Interactive comment on “Characteristics and drivers of baseflow response in 183 Australian catchments” by A. I. J. M. van Dijk

Anonymous Referee #3

Review report on manuscript Characteristics and drivers of baseflow response in 183 Australian catchments by van Dijk

Fig. 1.

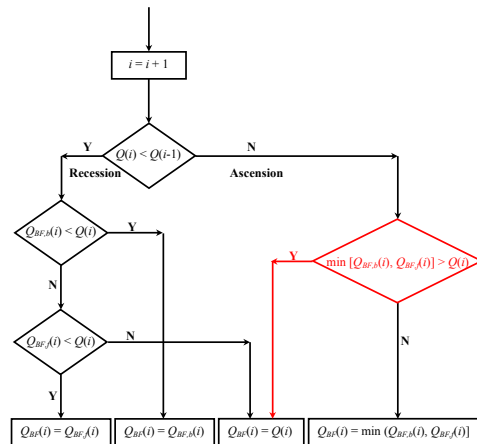
Section 3.4: A simple flow chart can be provided instead of or together with the decision tree. A simple chart based on the decision tree in the manuscript is made available in this report. Two questions for the rising limb of the hydrograph: (1) why does the author prefer the backward filter? (2) In the decision tree, there is an open point. The case when neither the forward nor the backward baseflow is less than streamflow is not mentioned. Although it is physically clear that baseflow cannot exceed streamflow in the river, this should be mentioned for the completeness of the decision tree (See red

part in the flow chart).
